## **42 Beacon Hill Road, Beacon Hill**

### Comments on Updates to Plans

## **PRELIMINARY GEOTECHNICAL ASSESSMENT:**

Photo 1

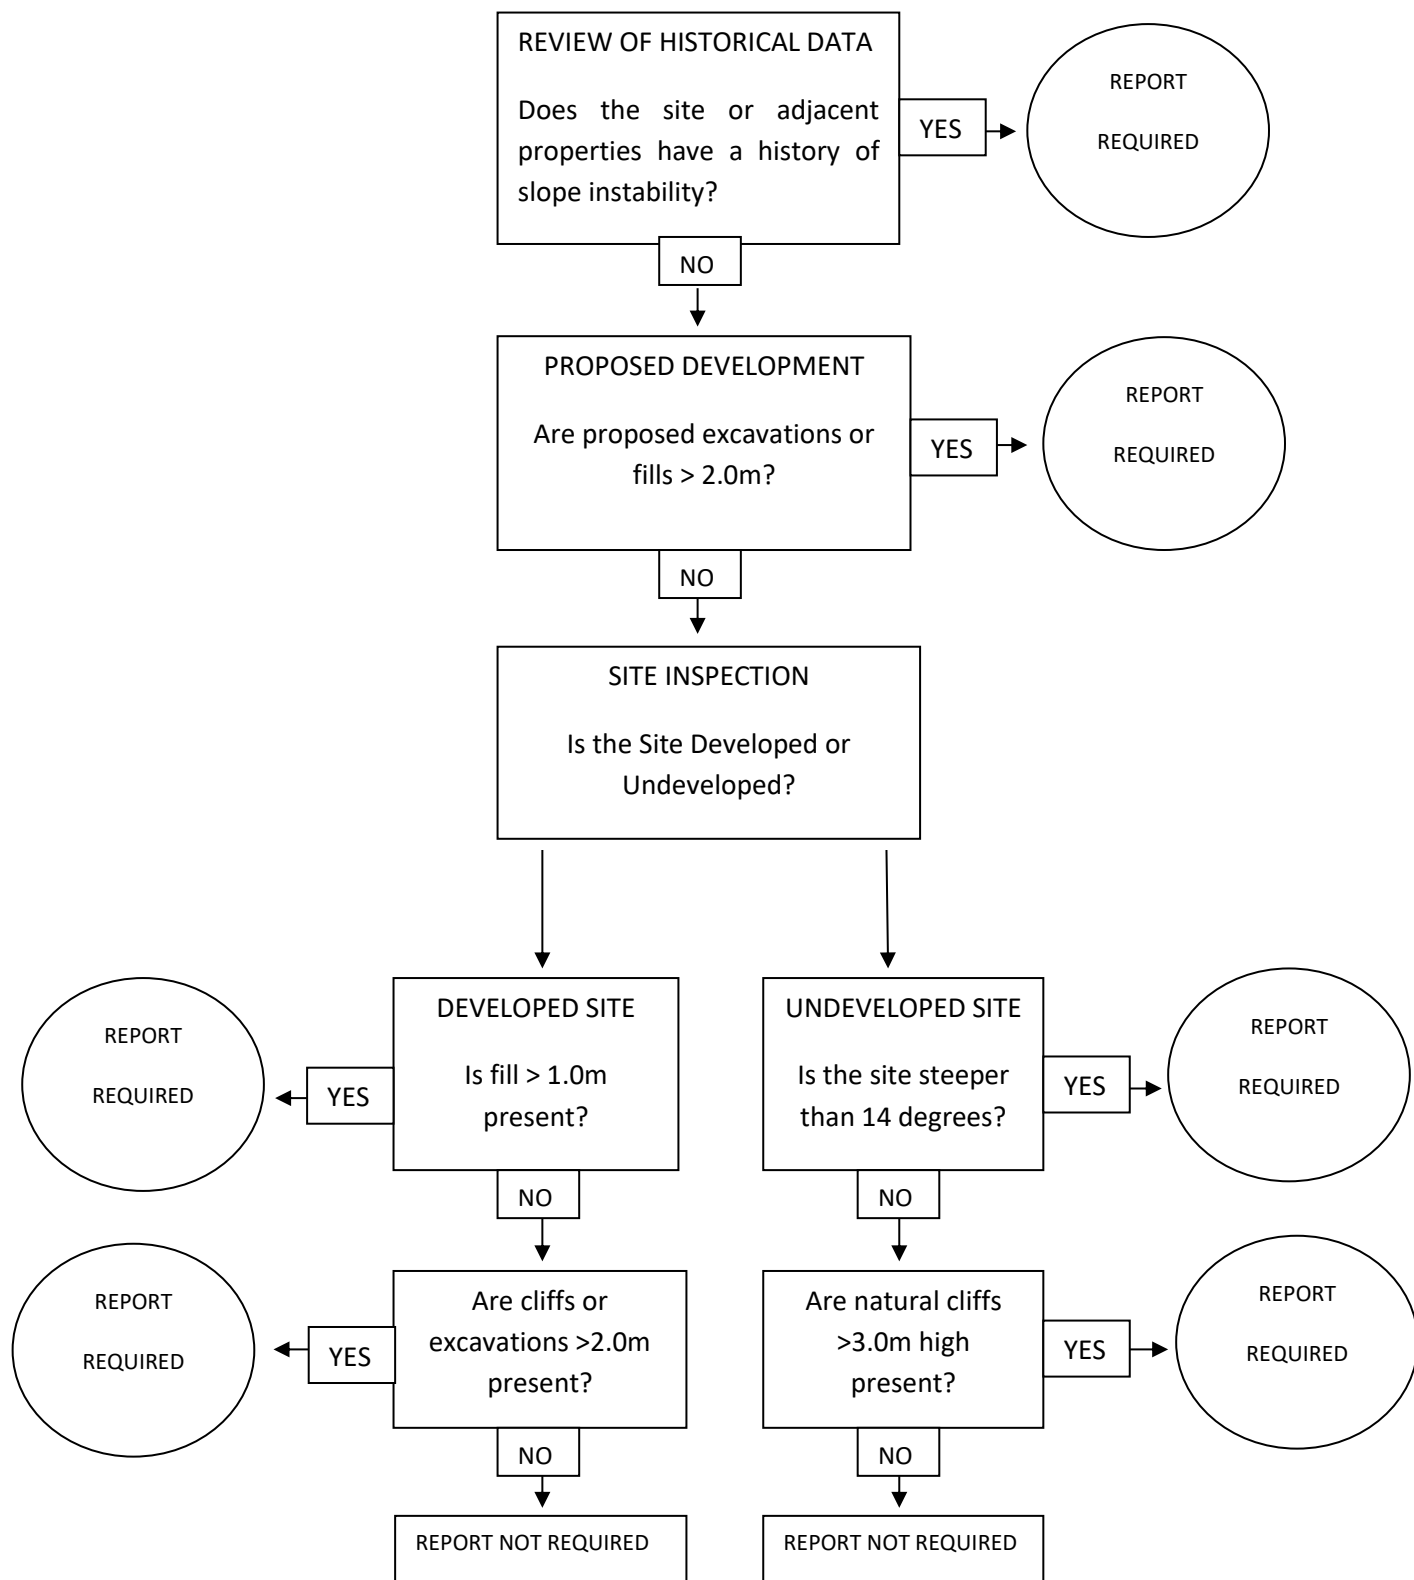
The concrete block retaining wall supporting the fill on the NW neighbouring property is cracked and shows minor settlement (Photo 1). To be prudent, we recommend the retaining wall be inspected by the owners on an annual basis or after heavy prolonged rainfall, whichever occurs first, keeping a photographic record of the inspections. We can carry out these inspections upon request. Should any new movement be observed, the geotechnical consultant is to be engaged to assess the movement and provide remedial advice if necessary.
